This is about the Winston-Salem C&D Landfill

This note and accompanying segments of Drawing C-6 from the Winston-Salem C&D Landfill "Construction Plan Application" are sent as initial response to your comments and our telephone conversation of September 20, 1995.

Subject: Site Plan Application  
Proposed Winston-Salem Construction and Demolition Landfill  
Forsyth County

RE: Proposed Winston-Salem Construction and Demolition Landfill

829.5

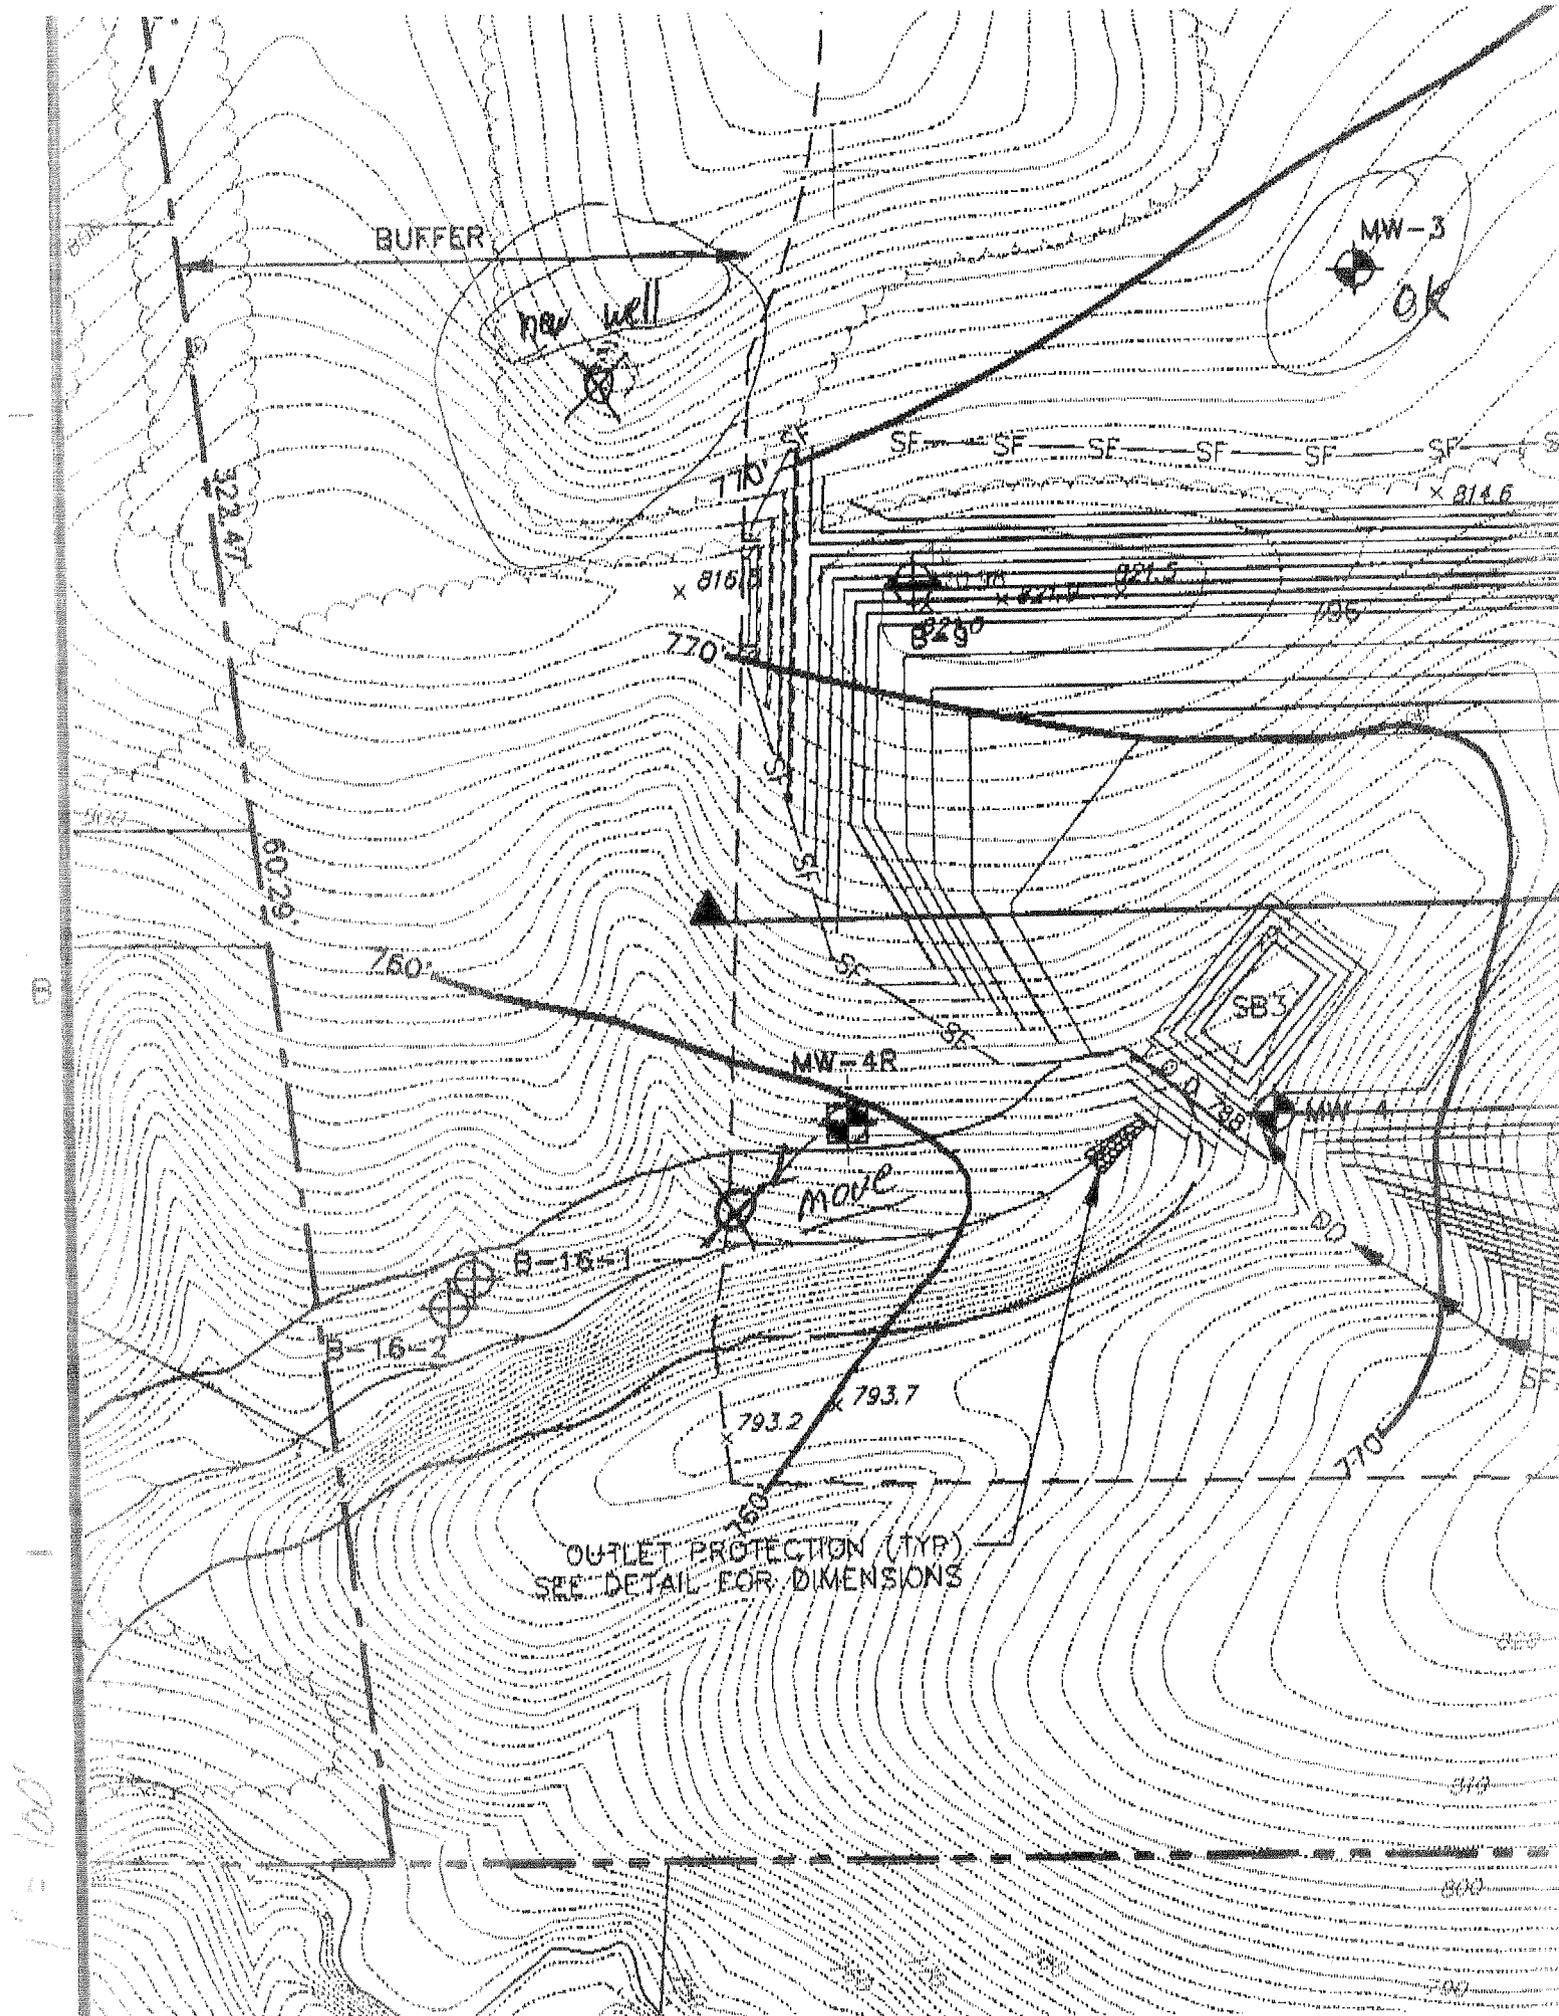
- ◆ Install an additional well to the northwest of the initial waste area. This new well is shown as "new well" on the accompanying maps. We agree that this well could form an important component of the ground-water monitoring system, particularly in light of the drinking water wells at residences located just to the west.

- ◆ In the "Construction Plan Application," we had proposed to install two new wells, MW-1R and MW-4R to replace MW-1 and MW-4, which are located in the footprint of the waste cell. You felt that the proposed location of MW-4R would be better if placed near the surface drainage swales as shown on the accompanying map and that is fine with us. The proposed location for well MW-1R is fine as is.

- ◆ In the "Construction Plan Application," we had proposed to install a new well, MW-6, along the north edge of the current fill area. You commented that you would like to see this new well placed near the drainage swale as shown on the accompanying map.

In our conversation, you also requested that existing well MW-5 be abandoned and a new well be placed approximately 100 feet west, again near a drainage swale. I strongly feel that this is an unnecessary burden for our client and that the existing well is already positioned to provide the required ground-water monitoring in this area. Allow me to elaborate.

In our conversation, you mentioned that both you and Bobby Lutfy apparently feel it is important to place wells completed in saprolite near drainage features because you believe that these features are an expression of fracture patterns or other linear features inherited from the precursor bedrock. I understand this general rationale but disagree on the details. In my experience, fractures in Piedmont bedrock typically occur as joints in the rock which are developed on a regional scale. The most important point here is that these joints are closely spaced - usually at a scale of inches to a few feet. Thus, inherited "fractures" in saprolite would also be at this scale. When we do rose diagrams which may statistically show the overall fracture orientations in an area's bedrock, we always find many linear drainage features that are oriented at all directions and do not follow the regional "fracture" pattern. To relate an individual drainage feature to these "fractures" in saprolite is problematic at best. In addition, with closely spaced fractures the norm

in Piedmont rocks, a ground-water monitoring well will normally intercept these relict structures in saprolite, no matter its location.

The second point I want to make is that the dominant flow in saprolite is through the intergranular pore system. Yes, I agree that there can be "short circuits" from quartz veins and possibly from inherited fractures, but I believe that the bulk of flow takes place in the intergranular pore system. Obviously, well MW-5 is monitoring that pore system.

Third, let's consider the type of monitoring taking place at a landfill. In landfill monitoring, we are not looking at a point source but rather at a large area. Potential contamination from a landfill can enter the water table at many places. One does not expect narrow fingers of contamination to slide by the monitoring system.

Which leads me to my final point. By its fine-grained, poorly sorted nature, the Piedmont saprolite ground-water system has large dispersivity. We take advantage of this characteristic in having fairly large spacings between monitoring wells.

Taking all of these facts together, I see no reason to spend some more thousands of dollars of our client's money to shift a monitoring well to a location that, frankly, is in no objective way any better suited than its current location. Let's leave it where it is.
